Variance Request Form

Variance: VAR-017
 Request No.: Rev 2
 Date Submit: _____
 Date Approval Needed: _____
 Date Agency Received: _____
 Agency Reference No.: _____

DOI-BLM- CA- D070-2018-0080-DNA

**Tule Wind Project - Variance Request
(VAR)-017**

OVERVIEW - Areas Beyond Approved Permanent Disturbance Limits

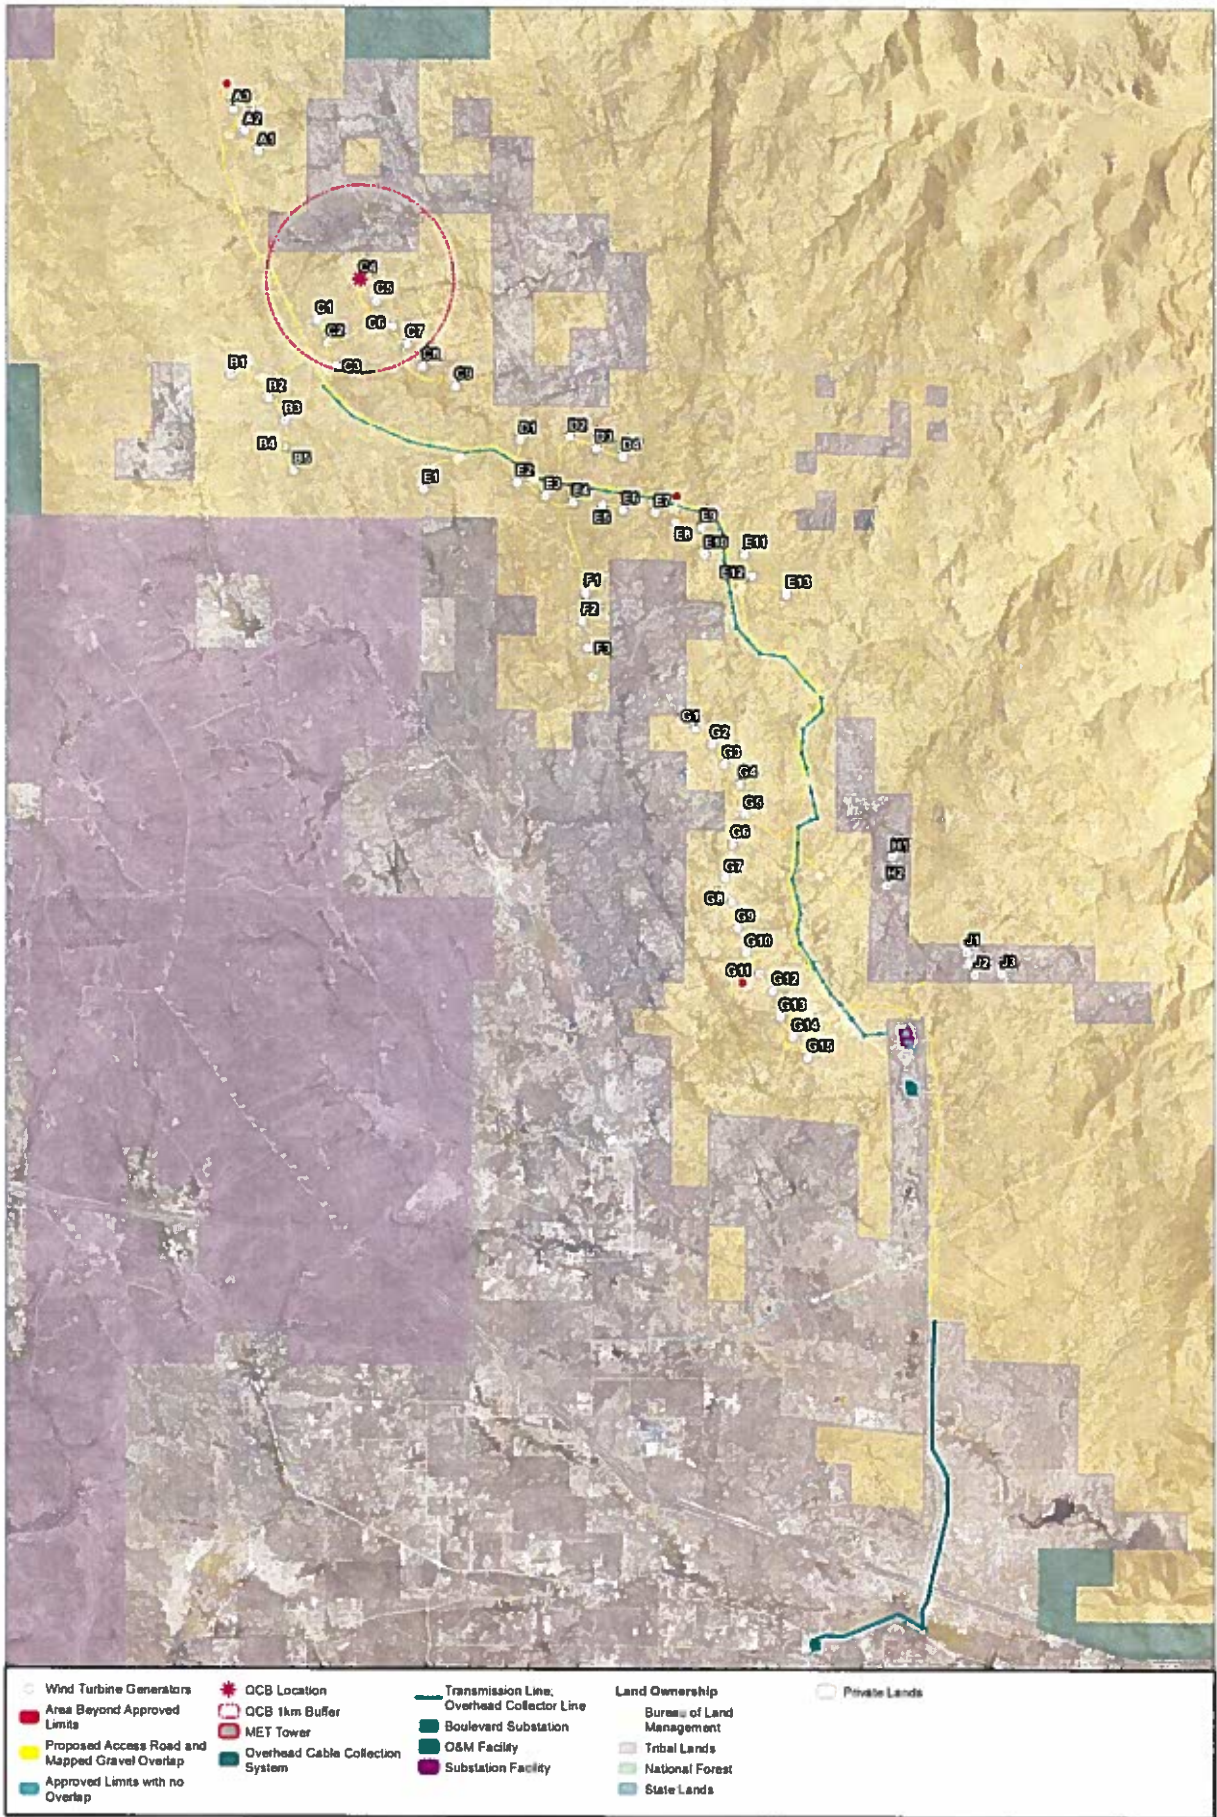
In accordance with the BLM letter dated April 3, 2018 and ROW Grant Stipulation #8 requiring the preparation of as-built drawings, Westwood Engineering surveyed the limits of gravel for the entire project area including McCain Valley Road and Project access roads in April 2018. Maps showing the limits of gravel mapped by Westwood Engineering are included as part of this DNA as **Attachment B**. The maps show the following:

- areas where the permanent impact areas associated with McCain Valley Road and Project access roads overlap with the limits of gravel,
- areas where permanent impact areas associated with McCain Valley Road and Project access roads do not overlap with the limits of gravel, and
- areas where the limits of gravel extend beyond the permanent impact areas associated with McCain Valley Road and Project access roads.

Approval of this VAR-017 will result in a total of 7.98 acres of additional permanent impacts associated with McCain Valley Road and Project access roads. This includes approximately 2.44 acres along McCain Valley Road and 5.54 acres along Project access roads. The 7.98 acres of permanent disturbance is shown in red in **Attachment B**. It is important to note that the permanent impacts being considered as part of VAR-017 have already occurred, but have not been permitted.
